**Re: 2025/92161 Whitehall Road West, Birkenshaw Planning Comments**

Following your enquiry, please see below a summary of the investigations undertaken to date at Whitehall Road West in response to the letter received from Kirklees Council (Ref. WK202536791) dated 26<sup>th</sup> November 2025.

*GRO-24205-P04 - Revised Illustrative Conceptual Site Model (CSM)*

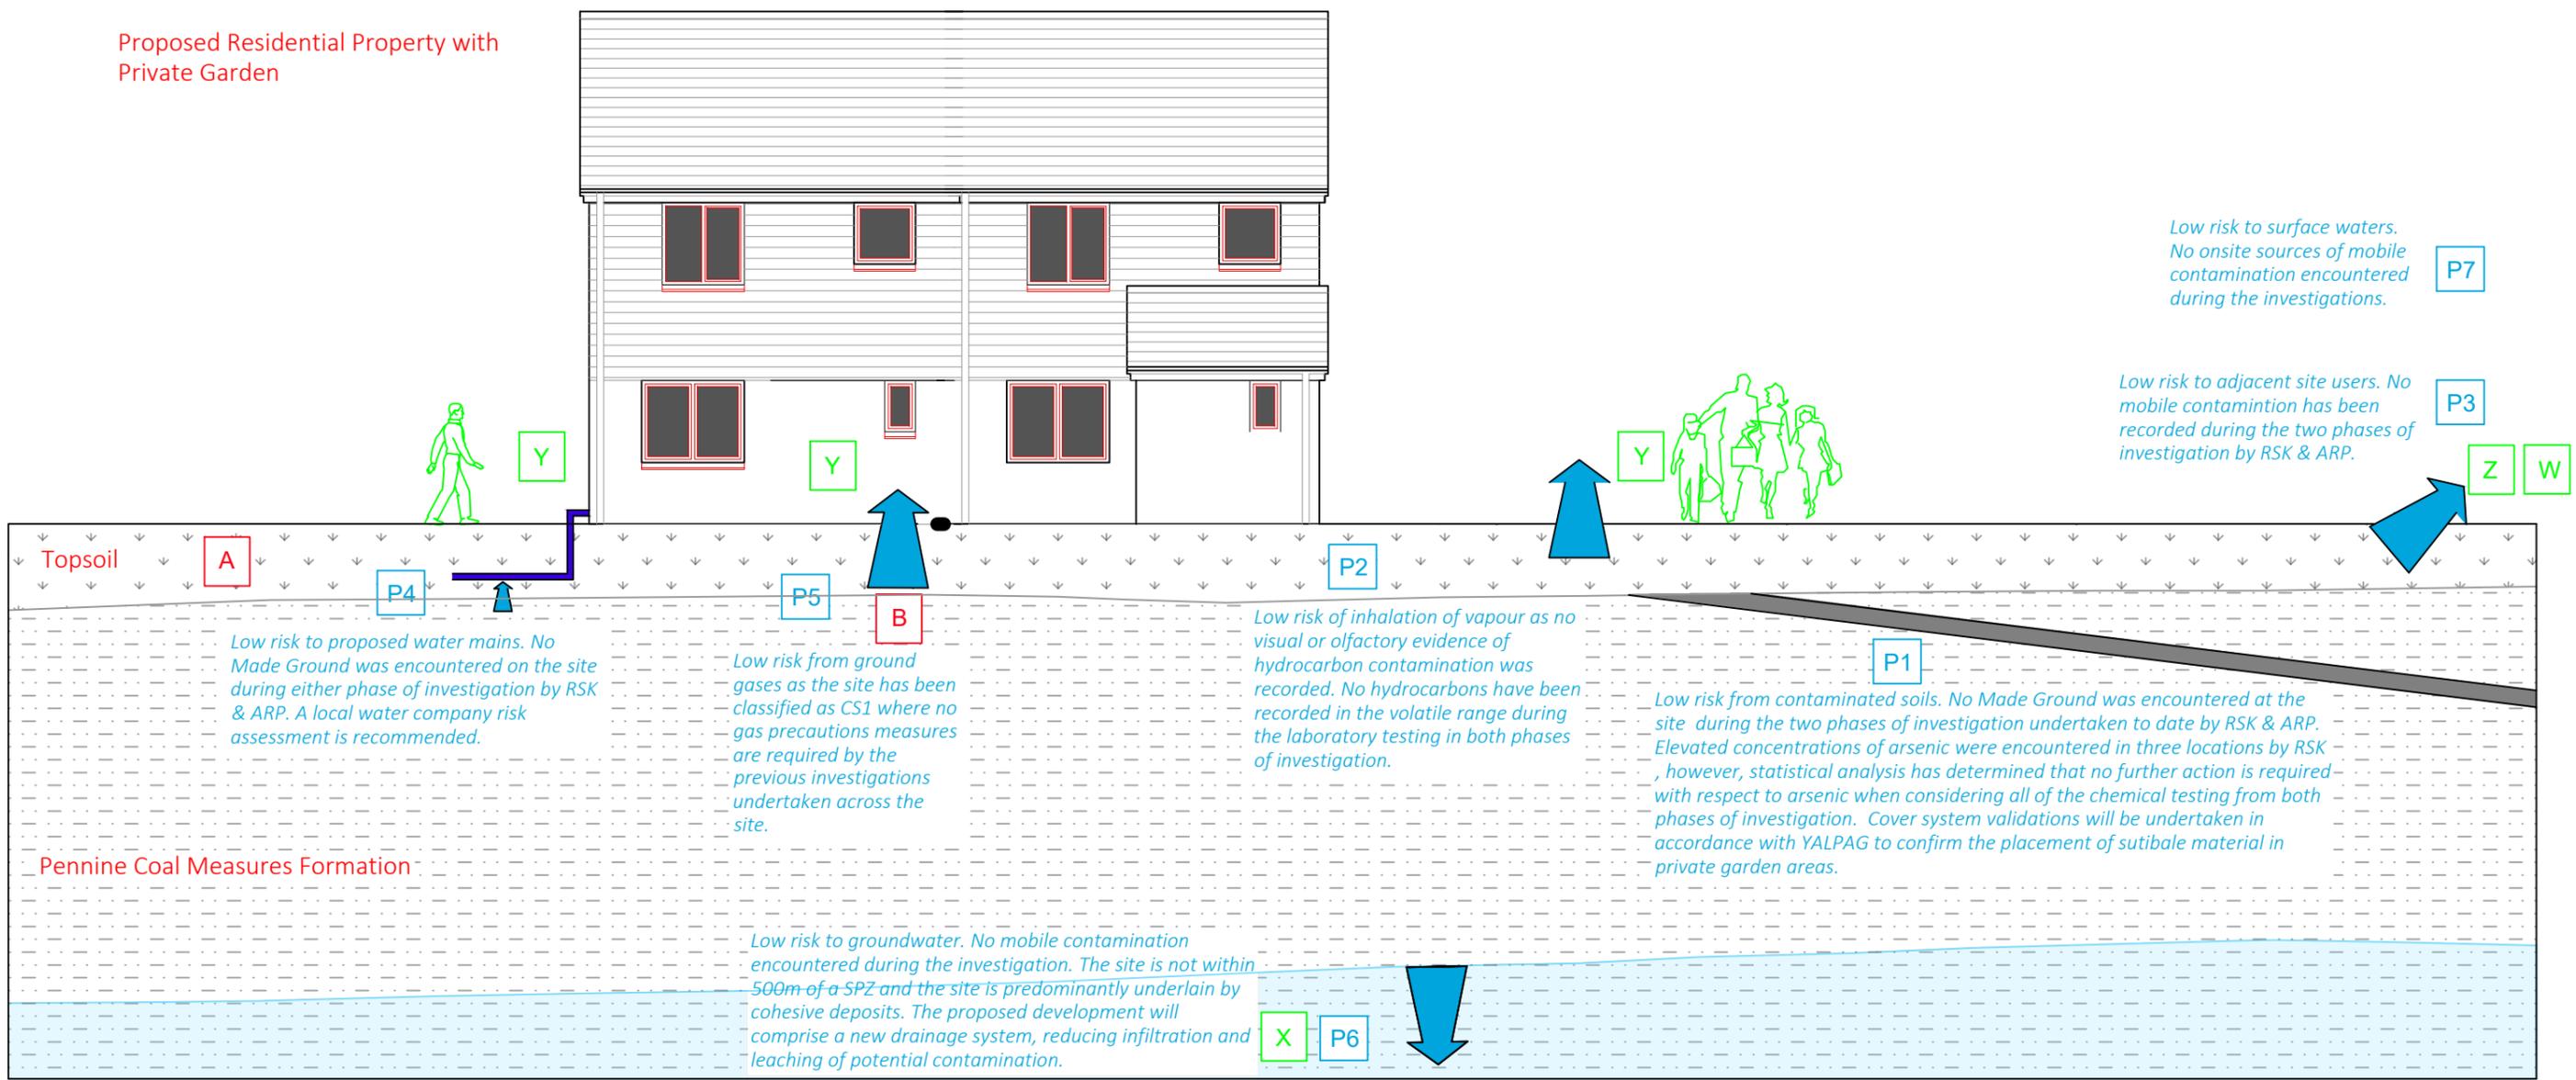
The comments from Kirklees relate to elevated arsenic concentrations recorded by RSK in the topsoil in the southern area of the site which require further assessment, the combustion and ground gas risk from shallow coal seams and the requirements for a complete site wide Conceptual Site Model (CSM). The comments are summarised below:

1. The reports previously submitted cover the northern and southern areas of the site respectively in isolation and have not characterised the site as a whole.

2. The report by RSK concluded that further sampling is necessary to fully investigate the exceedances for arsenic across the site, Kirklees do not accept the report authors description of the "slight exceedances" of Generic Assessment Criteria values (GAC), given that only 4 topsoil samples were submitted for analysis, with 3 of them exceeding values. Thus, the CSM for the site is not complete.

3. Although shallow coal has been identified at site from borehole and trial pit records, the combustion risk has not been fully addressed in relation to services, site levels and foundation depths have not been fully discussed in relation to gas risk and no detailed information has been given to explain if trial pits and rotary boreholes that penetrated the shallow coal layers on site have been safely backfilled.

In order to produce a site wide Conceptual Site Model (CSM) the results recorded must be considered a whole dataset and statistical analysis in accordance with CL:AIRE, 2020 "*Professional Guidance: Comparing Soil Contamination with a Critical Concentration*" has been undertaken by Groundtech Consulting to assess the results. Analysis was carried out on the 12 samples of topsoil obtained during the investigations by RSK Environment and ARP based on the observations and descriptions during the Ground Investigation. Based on the borehole and trial pit logs from the previous investigations it is considered that the topsoil recorded by RSK and ARP is the same soil population.

The statistical analysis for arsenic shows that the Confidence interval (17.92mg/kg to 34.03mg/kg) is less than the Critical Concentration (37.0mg/kg) for residential end use with plant uptake with a confidence level of 95%, meaning that the true mean also lies below the critical concentration and no further action is required with respect to arsenic for the natural topsoil at the site.

Based on the statistical analysis undertaken on the results previously recorded the risk to Human Health across the entire site area from contaminated soils is considered to be Low. No significant source of contamination has been recorded and the statistical analysis has determined that no further action is required with respect to the elevated arsenic recorded by RSK.

The combustibility of the coal seams was assessed as part of the Coal Mining Risk Assessment by Groundtech Consulting. Any excavated coal is to be treated as combustible and consideration into the prevention of ignition should be undertaken during groundworks in accordance with CIRIA C758. This will include deepening through coal for foundations when encountered and placing sufficient clay cover system in gardens to isolate for lifetime of development.

Ground gas monitoring undertaken at the site to date has placed the site within Characterisation Situation 1 (CS1) where no gas precaution measures are required, based on the monitoring results undertaken to date we would agree with this classification. Suspended floor slabs will be adopted for the proposed dwellings which will incorporate gas protection measures into the construction of the properties which provides an additional layer of confidence.

In order to fully assess that the risk from mine gas has been assessed appropriately, the CL:AIRE Good Practice for Risk Assessment for Coal Mine Gas Emissions, 2021 guidance document has been used to adopt a multiple lines of evidence approach that covers not only the guidance in BS 8485 but also oxygen depletion and emissions through voids and fractured rock.

The Decision Support Tool for Mine Gas Risk Assessments has been used to aid the mine gas assessment which classed the site as being a *Moderate* Risk Zone. This is based on the adit lying between 20m and 50m from the site boundary.

During the gas monitoring undertaken during the previous investigations a maximum positive flow rate of 0.2l/hr was recorded in the locations and no depleted oxygen levels were recorded during the monitoring periods, therefore indicating that no voids or fractured rock is present beneath the site and depleted air is not migrating upwards.

The Coal Authority Interactive Map viewer shows that the site does not lie within a Development High Risk Area and no past or probable shallow coal mine workings are indicated to be present beneath the site. The gas monitoring results show there is not sufficient evidence to require increasing the site to a CS2 classification. Hydrogen sulphide was been recorded at a maximum concentration of 1ppm which is considered to be negligible and not pose a risk to the development and carbon monoxide has been recorded at a maximum concentration of 23ppm during the monitoring.

At these concentrations carbon monoxide is not considered a risk based on Table D.1 of BS 8576:2013 where the minimum concentration that symptoms would be observed is 35ppm. Natural soils produce carbon monoxide as a result of chemical oxidation of small quantities of organic matter. It is regularly detected in natural soils and unless there is an external source such as a smouldering landfill it does not pose a risk to development. The production is transient and is probably dependent on rainfall. The carbon monoxide sensor on the most commonly used gas meters is also cross sensitive with hydrogen.

No risk from the accumulation of permanent ground gases is considered to exist.
